| WELL API NO. 30-025-30008 |
| 7. Lease Name or Unit Agreement Name WEST DOLLARHIDE QUEEN SANDS UNIT |
| 8. Well Number 85 |

WELLBORE DIAGRAM
WEST DOLLARHIDE QUEEN SAND UNIT #85
CURRENT
API: 30-025-30008

WELLBORE DIAGRAM
WEST DOLLARHIDE QUEEN SAND UNIT #85
PROPOSED
API: 30-025-30008

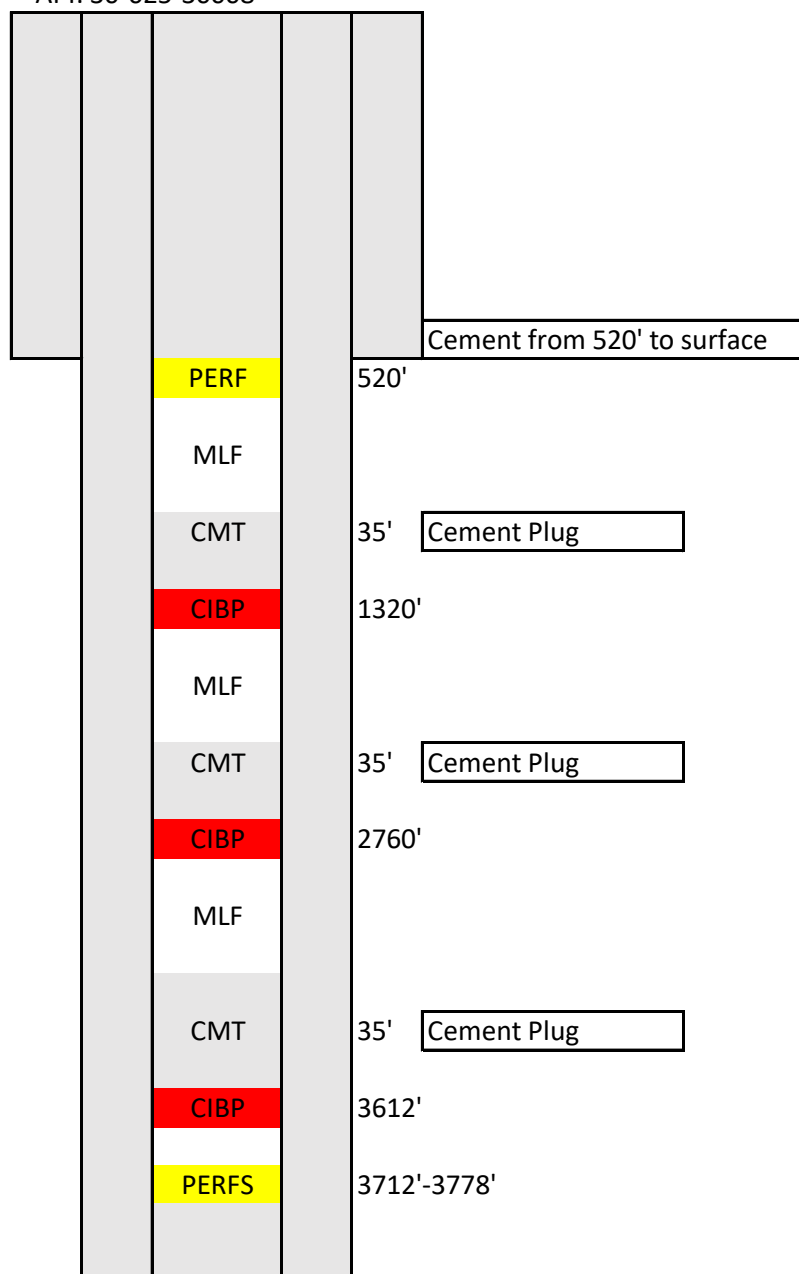
Circ MLF Pressure test csg

4" diameter 4' tall Above Ground Marker

SEE ATTACHED CONDITIONS
 OF APPROVAL
